Re: Niagara Mohawk Power Corporation
Nine Mile Point Nuclear Station,
Unit No. 1
Docket No. 50-220

APPLICATION FOR AMENDMENT

Proposed Changes to Technical Specifications

Supporting Information

Figure 6.2-1
Nine Mile Point Nuclear Station
Management Organization Chart

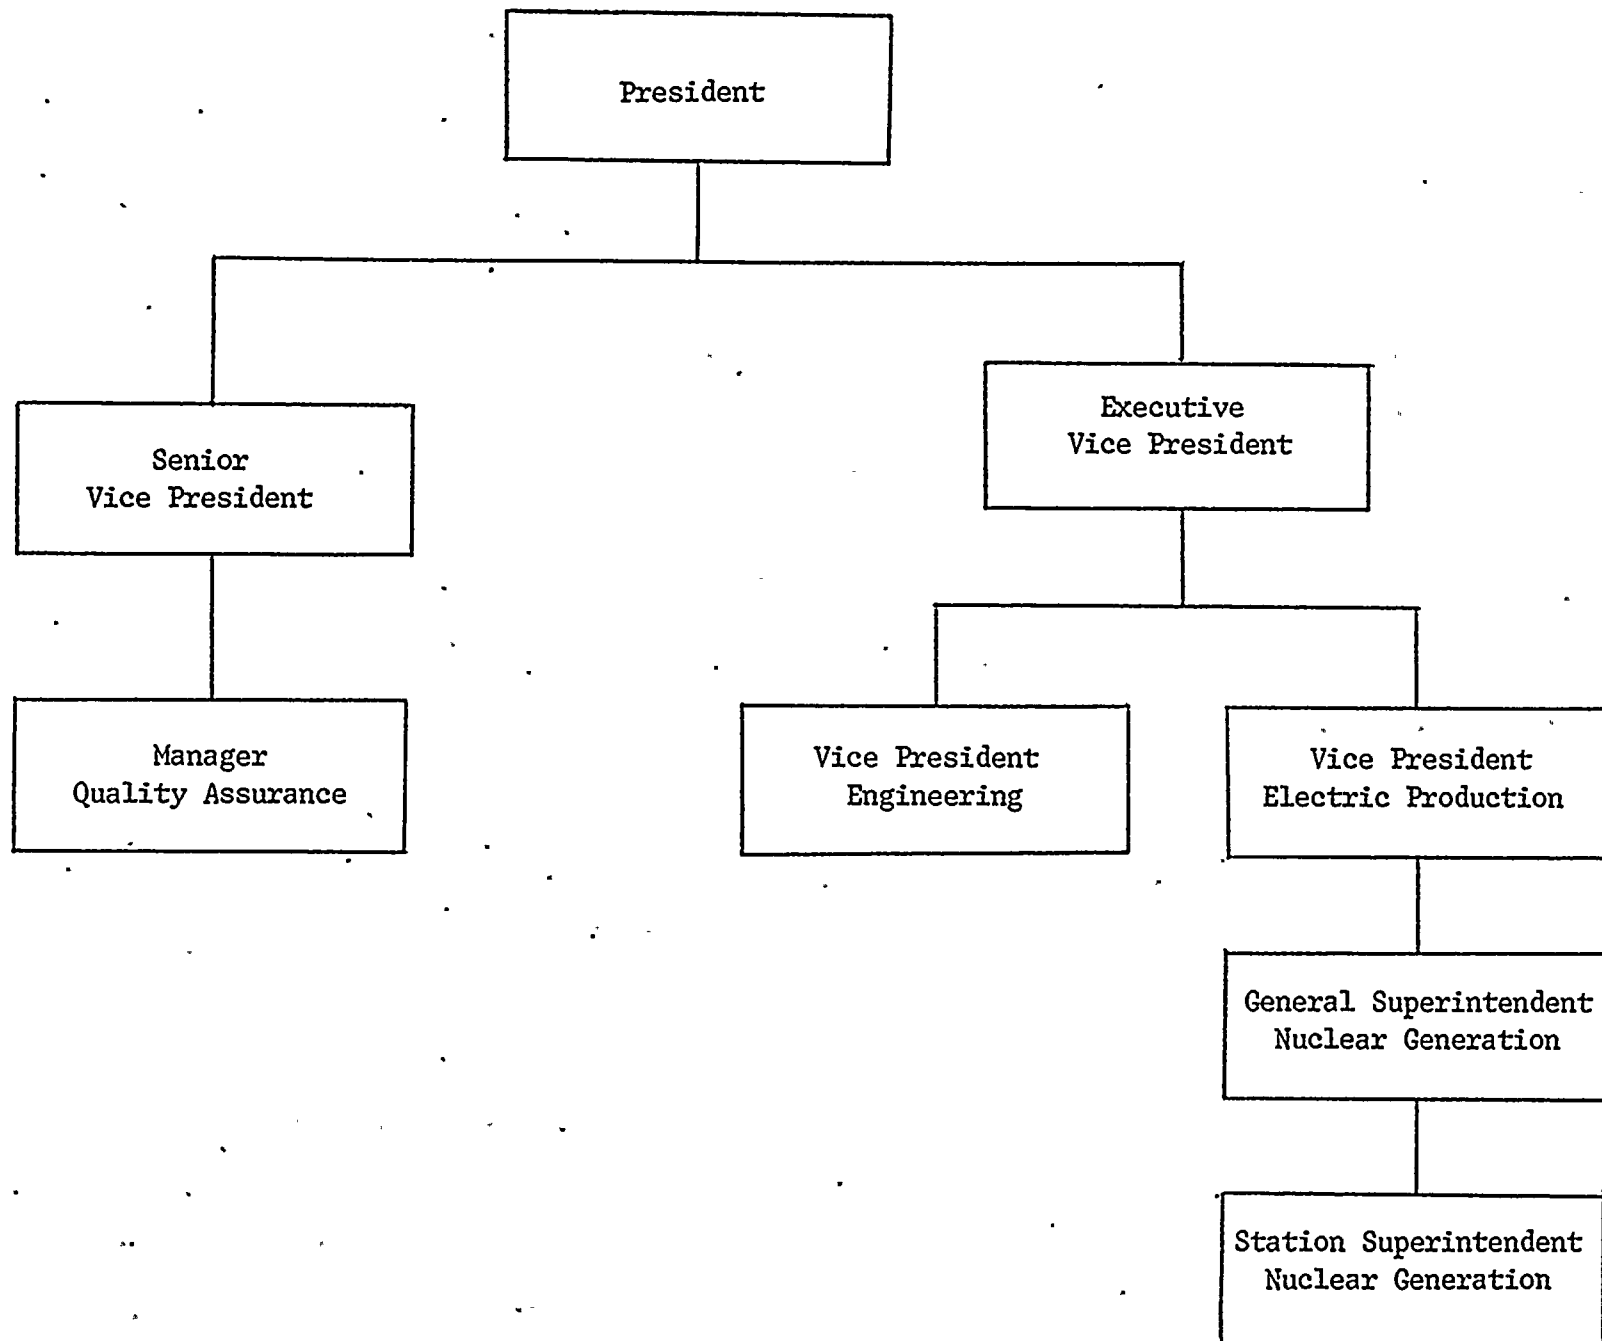
Pursuant to Section 50.90 of the regulations of the Nuclear Regulatory Commission, Niagara Mohawk Power Corporation, holder of Facility Operating License No. DPR-63, hereby requests that Sections 6.5.1.2, 6.5.1.6, 6.5.1.7, 6.5.1.8, 6.5.2.2, 6.5.2.8, 6.5.2.9, 6.5.2.10, 6.6.1, 6.7.1 and Figures 6.2-1 and 6.2-2 of the Technical Specifications and Bases set forth in Appendix A to that License be amended. The proposed changes have been concurred with by the Site Operations Review Committee and the Safety Review and Audit Board.

These proposed changes reflect the changes in operating responsibility for the James A. FitzPatrick Nuclear Power Plant. These changes also reflect current Niagara Mohawk onsite and offsite organization for facility management. It is expected that the new organization will improve facility management and provide for more effective reporting. The Site Operations Review Committee and the Safety Review and Audit Board will retain adequate membership to provide the expertise required by ANSI N18.7-1972.

FIGURE 6.2-2
NINE MILE POINT NUCLEAR SITE
OPERATION ORGANIZATION

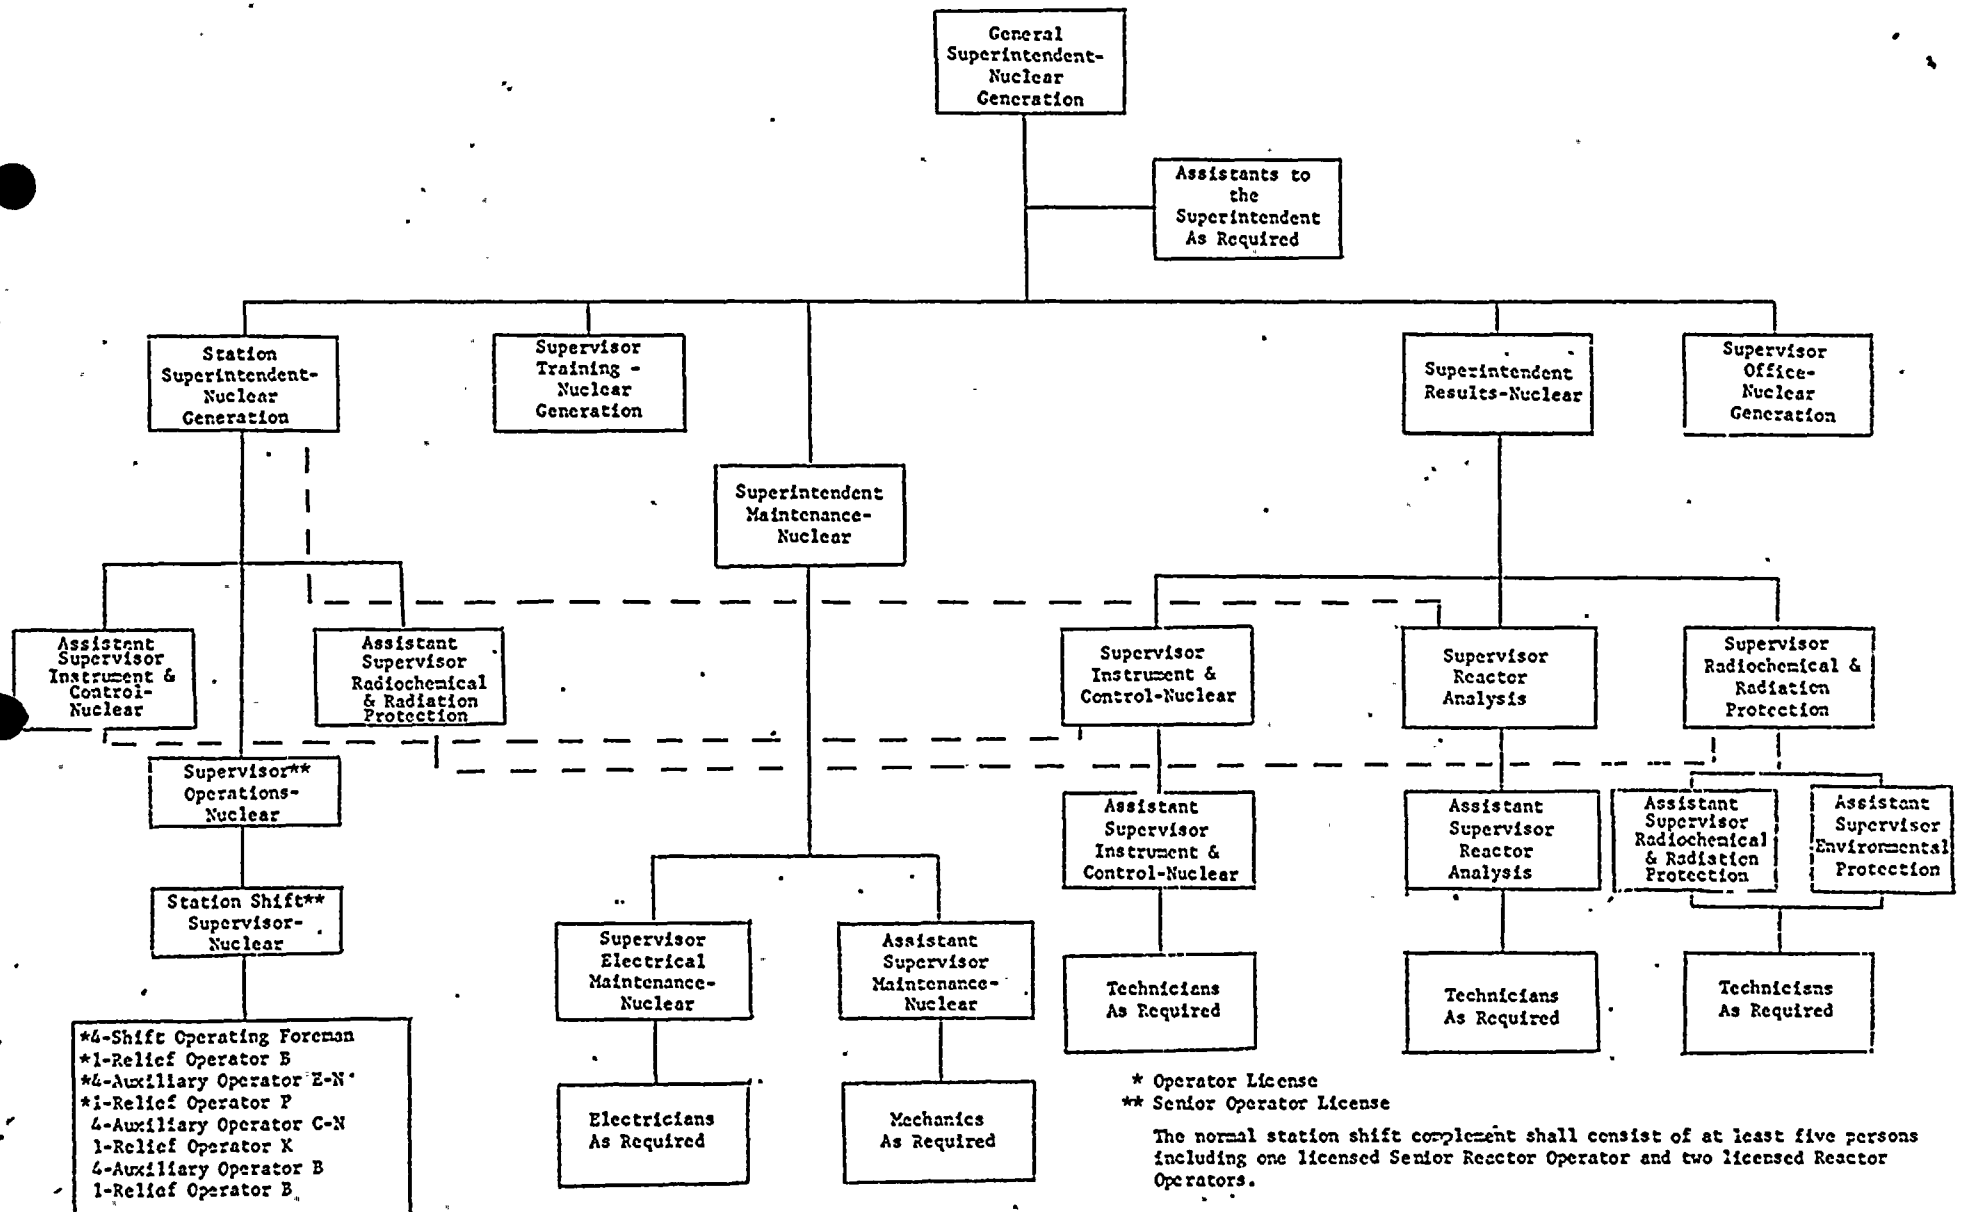
- 1) eliminate the James A. FitzPatrick Nuclear Power Plant from the Nine Mile Point Nuclear Site Organization (Figure 6.22)
- 2) to eliminate representation of the Power Authority of the State of New York from the Site Operations Review Committee and Safety Review and Audit Board and
- 3) to reflect changes in the Niagara Mohawk onsite and offsite organizations.
